AUSPLOW FARMING SYSTEMS

PARTS BULLETIN No. 1-15

Subject: **NEW PART** - **ACCUMULATOR 20LTR WITH ADAPTOR 05712**
 - **REDUCER BUSH - ACCUMULATOR ADAPTOR 27092**
 - **O-RING 70.0 x 3.5mm 27264**

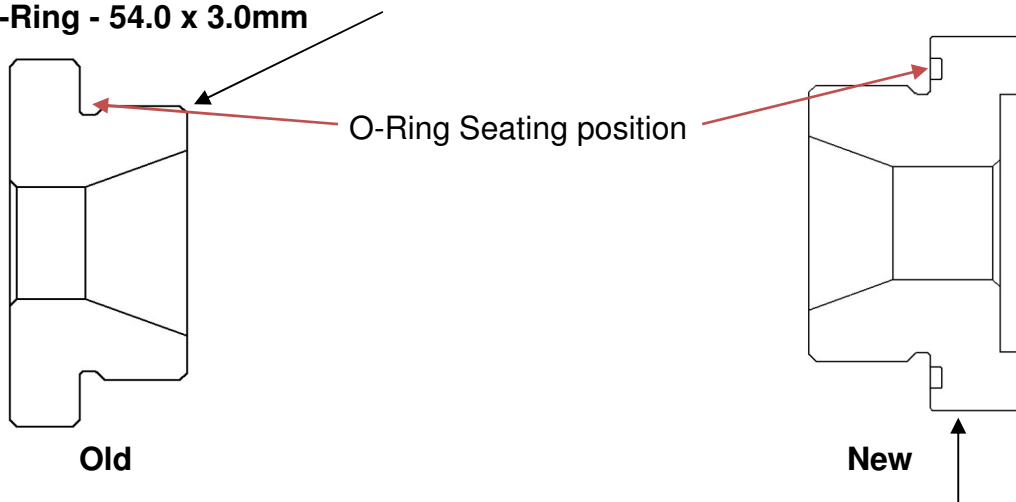
In late 2014 Ausplow made a change to the hydraulic accumulator which resulted in new accumulator adaptors and O-rings now fitted on all new machines.

The new style accumulator adaptors and O-rings are **not directly interchangeable** with each other because of the change in fittings, seating position and O-ring size, therefore caution must be exercised when ordering replacement O-rings, or adaptors.

08261 Reducer Bush - Accumulator Adaptor- 2" BSPP M O-Ring To 3/4" BSPT F
09361 O-Ring - 54.0 x 3.0mm

27092 Reducer Bush – Accumulator Adaptor
2" BSPP M O-Ring To 3/4" BSPT F
27264 O-ring 70.0 x 3.5mm

Ausplow highly recommends measuring the O-ring diameter before placing orders, to help identify replacement adaptors and O-rings this can be confirmed by the O-ring seating position on the adaptors, as shown above.

Please Note: Accumulator 20L part number 05529 has been superseded and replaced with **P/N 05712 Accumulator 20Ltr with Adaptor.**
